APPLICATION FOR AUTHORIZATION TO INJECT

C-108 Application for Authorization to Inject
SWD 4-22-27 No. 1
(Compadres Fee No. 2)
2310' FNL 1060' FEL
H-4-22S-27E, Eddy County

From: Brian Collins [engineering@marbob.com]
Sent: Monday, April 23, 2007 4:59 PM
To: Jones, William V., EMNRD
Subject: Re: SWD Application: SWD 4-22-27 #1 API No. 30-015-34935 (was the Compadres Fee #2)

From: Jones, William V., EMNRD
Sent: Wednesday, April 11, 2007 4:17 PM
To: Brian Collins (engineering@marbob.com)
Cc: Arrant, Bryan, EMNRD; Ezeanyim, Richard, EMNRD
Subject: SWD Application: SWD 4-22-27 #1 API No. 30-015-34935 (was the Compadres Fee #2)

Before Conversion

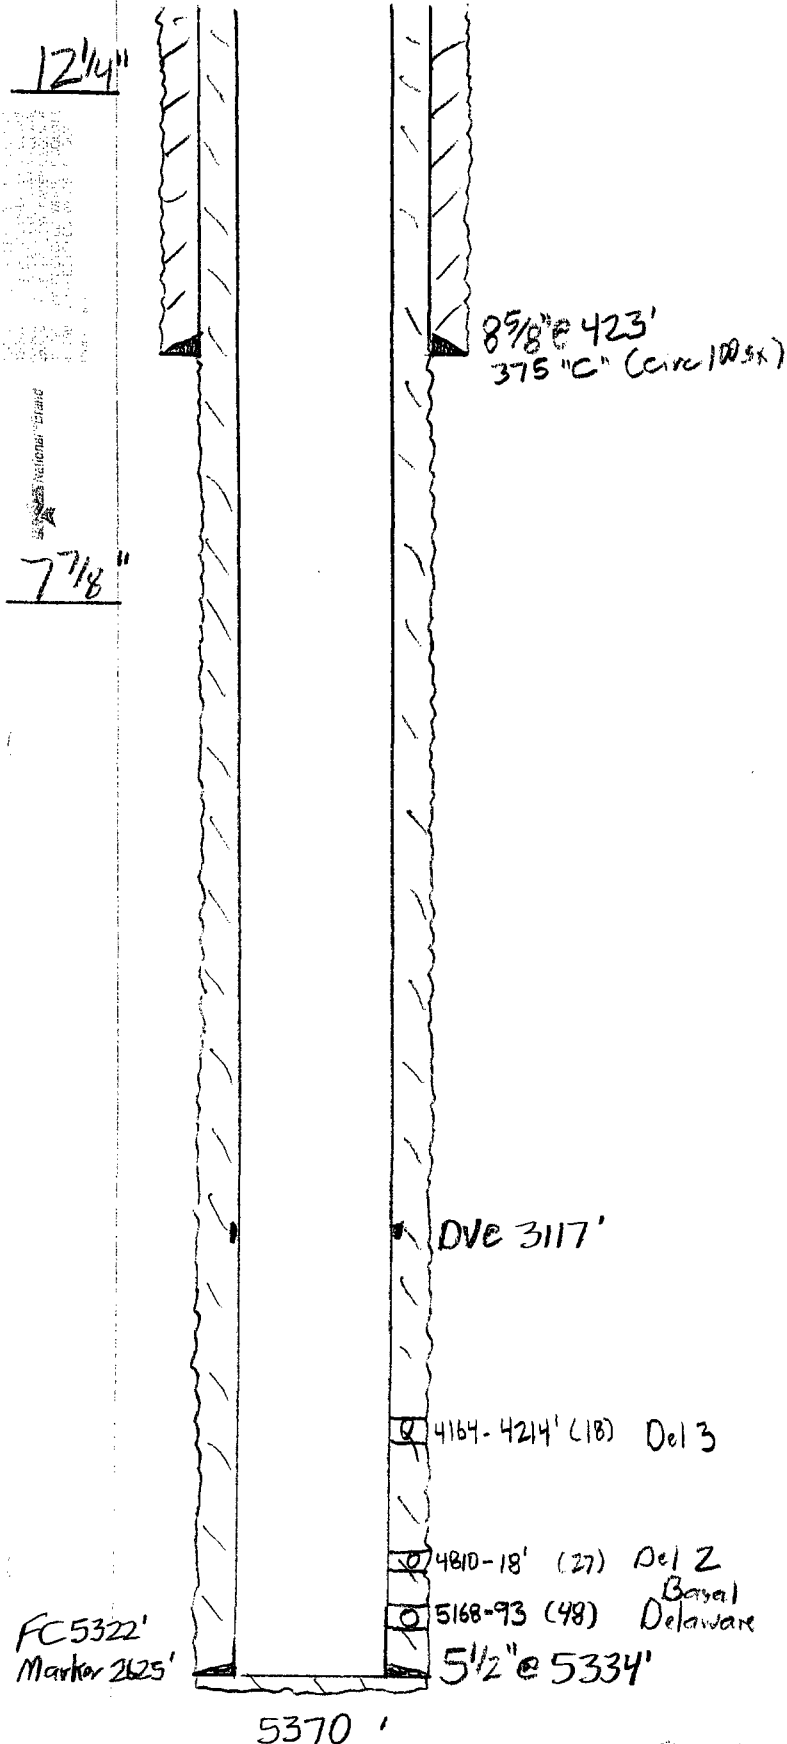
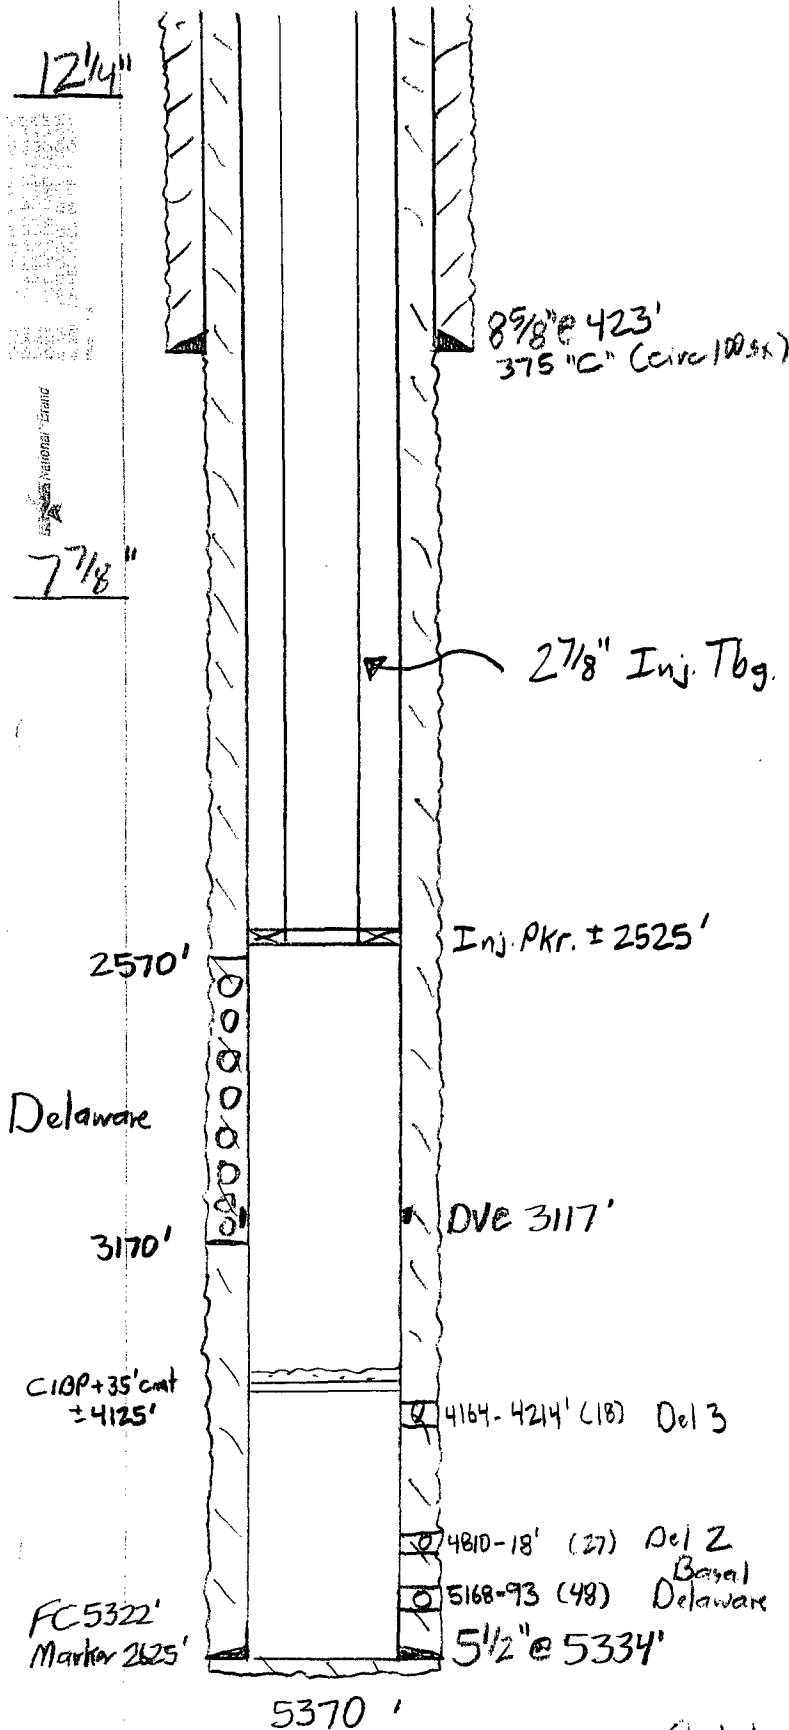
1. Plug back with CIBP to 200' below bottom of injection interval.

- 1) We'll require Marbob to plug back with a CIBP to approx 200 feet below the lowermost injection interval.
- 2) The well was deviated, but not very much. Why was it deviated?

Answer: We don't think an additional CIBP 200' below the bottom perf is necessary; however, we don't have a problem with this. Instead of setting an additional CIBP, could we set the CIBP + cement proposed for 4125' at 3350' instead?
